Access Compliance Report

Public Rights-of-Way

(Curb Ramps)

Intersection ID: 25402	Main Street: HONEY_CREEK_LN	Cross Street: WEDDINGTON_RD	Location: NW
ADA ID: C5BD07B215B4	Ramp Type: Perp	Initial Pass/Fail: Fail	Overall Compliance: No
		Severity Score: 8.75

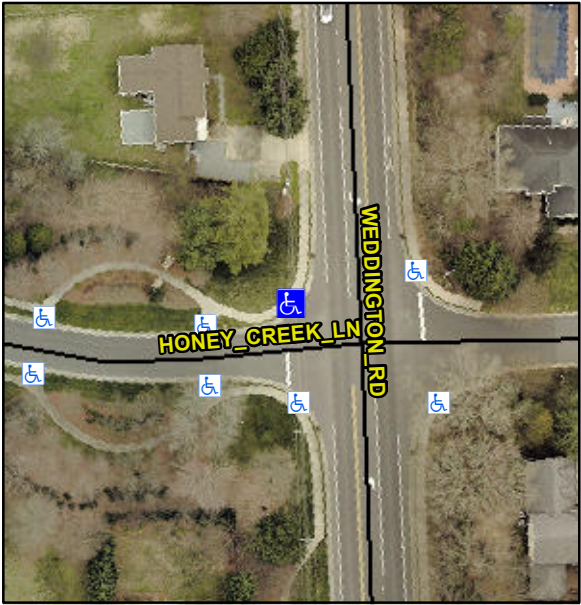
Codes/Mitigation Info/Possible Solution			Field Measurements/Component Compliance		
	Possible Solutions:		Compliance	Description	Data
	Remove & Replace Entire Ramp.		Yes	Ramp Length (in)	72.0
			No	Ramp Width (in)	47.0
			N/A	Flare Type LT	N/A
			N/A	Flare Slope LT (%)	N/A
			N/A	Flare Traversable LT?	N/A
			N/A	Landing Length (in)	N/A
			N/A	Landing Width (in)	N/A
			N/A	Landing Slope (%)	N/A
			N/A	Landing X Slope (%)	N/A
<p>Surveyor Notes:</p> <p>N/A</p> <p>PROW/ADA:</p> <p>Not Found, R304.5.1</p>			N/A	Flare Type RT	N/A
			N/A	Flare Slope RT (%)	N/A
			N/A	Flare Traversable RT?	N/A
			N/A	DWS Provided?	N/A
			N/A	DWS Contrast?	N/A
			N/A	DWS Length (in)	N/A
			N/A	DWS Full Width?	N/A
			N/A	DWS Offset (in)	N/A
			N/A	Gutter Ponding?	N/A
			N/A	Gutter Lip Ht (in)	N/A
			No	Painted X Walk1?	N/A
				X Walk 1 Direction	To S
			N/A	X Walk 1 Width (in)	N/A

0.9	X Walk 1 Slope (%)	N/A
			1.6	X Walk 1 X Slope (%)	N/A
			N/A	Ramp inside XWalk1?	N/A
			N/A	Road Slope (%)	N/A
			N/A	Road X Slope (%)	N/A
			N/A	Any Obstructions?	N/A
				Obstruction Type	
Total Cost: \$ 1850.00			N/A	Storm Grate/Utility Hazard?	N/A
			N/A	Storm Grate/Utility Type	N/A
			Yes	Surface Condition? (G/P)	Good
